CMD: 25-H104

A Licence Amendment

**Cameco Corporation
McArthur River
Operation – Financial
Guarantee Review
Cigar Lake Operation –
Financial Guarantee
Review and Licence
Amendment**

Submitted by:
CNSC Staff

The location of the Cameco's operation at Cigar Lake is shown on Drawing C400-G-136, Rev. J.

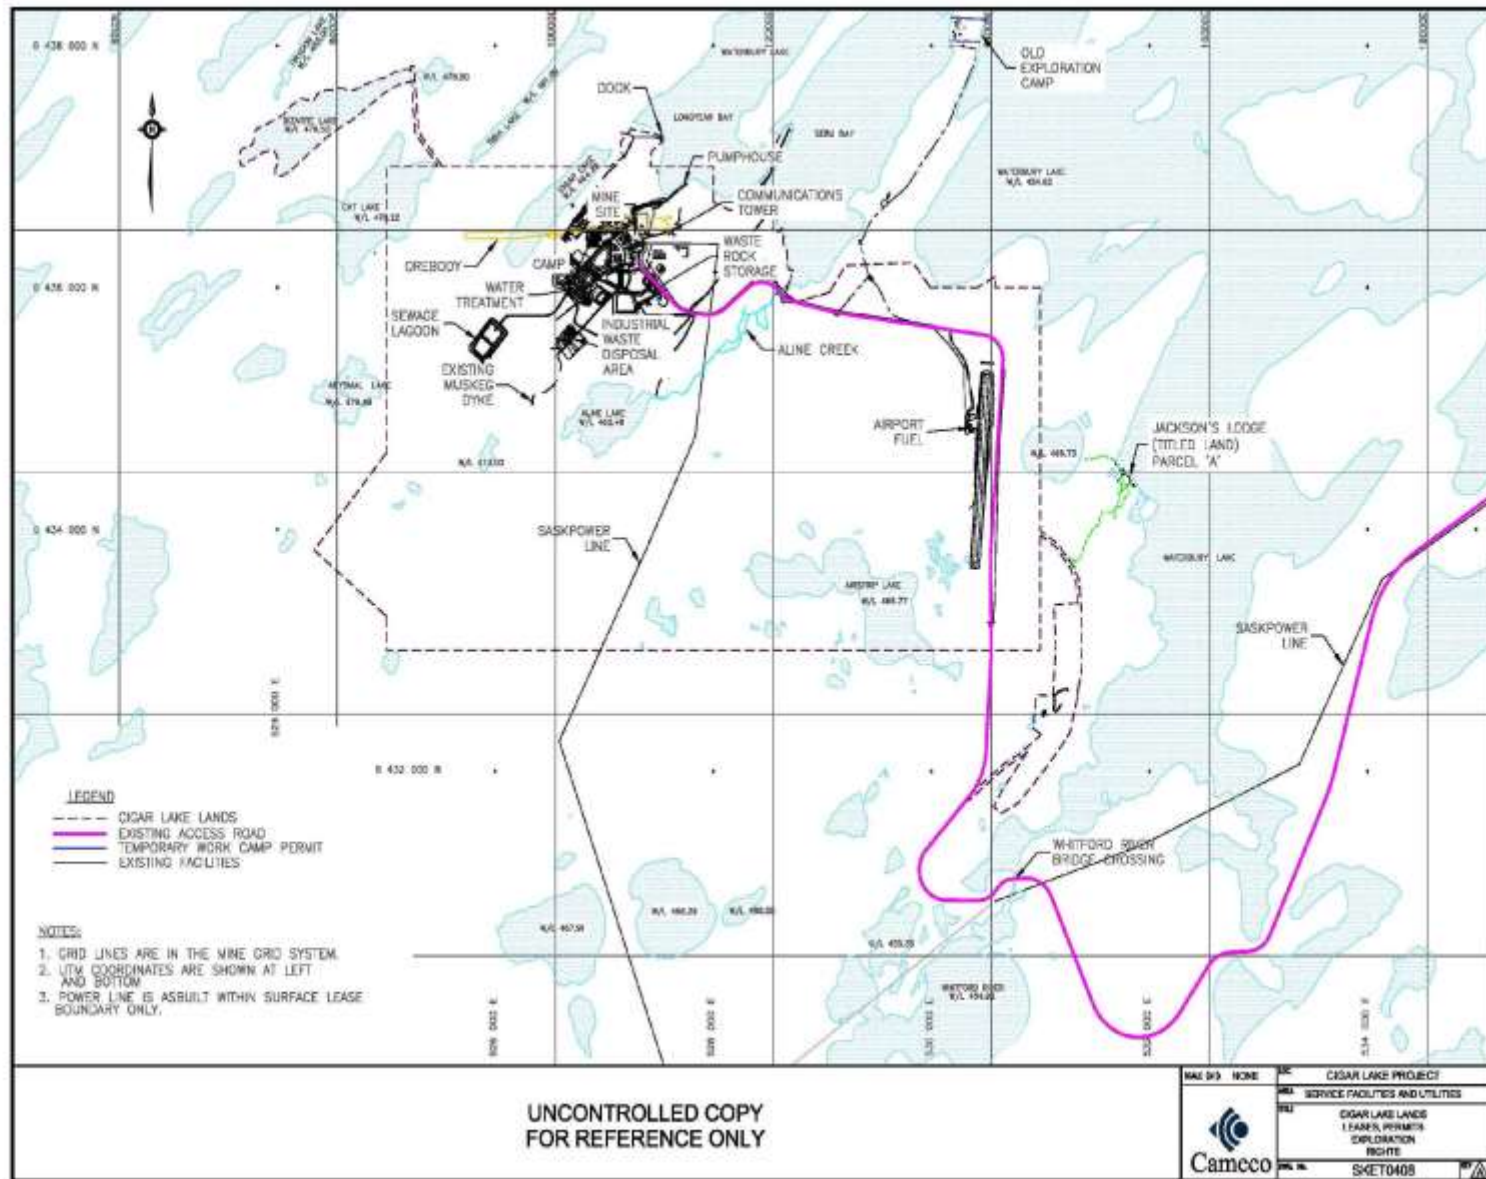
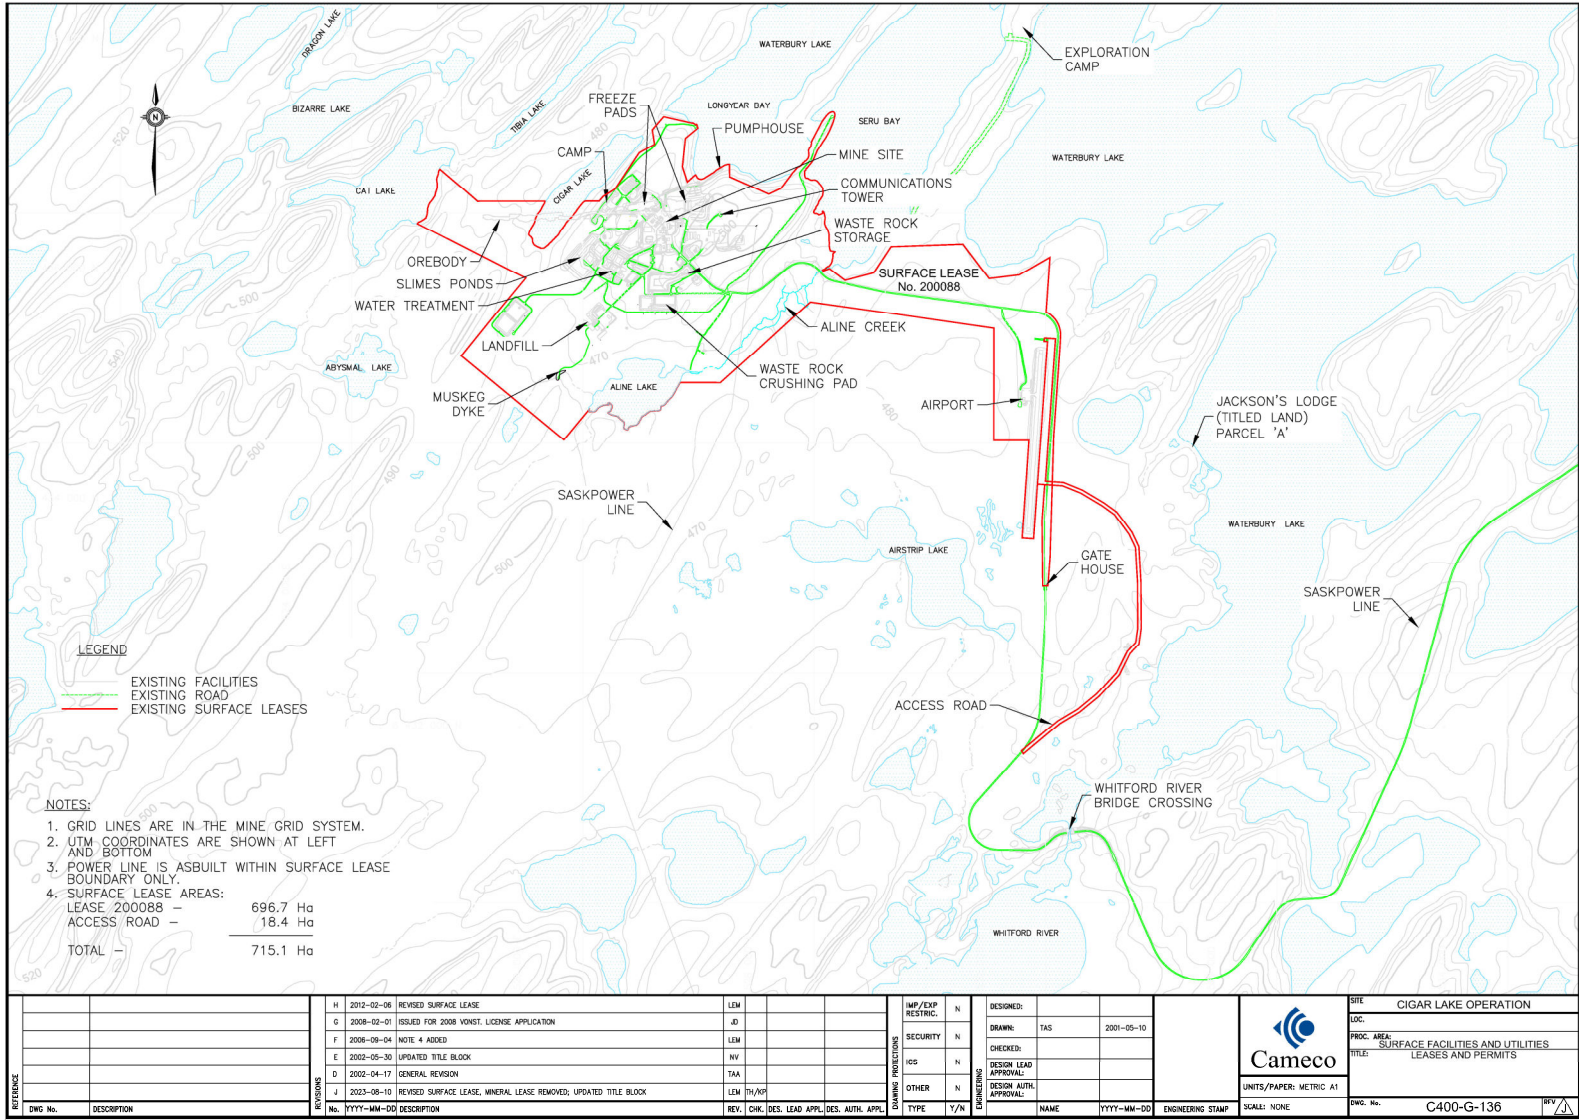
In addition, the provincial surface lease agreement boundary was amended on April 1, 2023. As a result of that change, Cameco requested an amendment to the drawing in Appendix A of the licence to show the updated lease boundary. No other licence changes are proposed.

Amendment to replace the current drawing in Appendix A of the licence to reflect the amended Cigar Lake Surface Lease Agreement 2011, as amended by the Government of Saskatchewan, effective April 1, 2023.

CNSC staff recommend that the Cigar Lake licence be amended to include the revised site map.
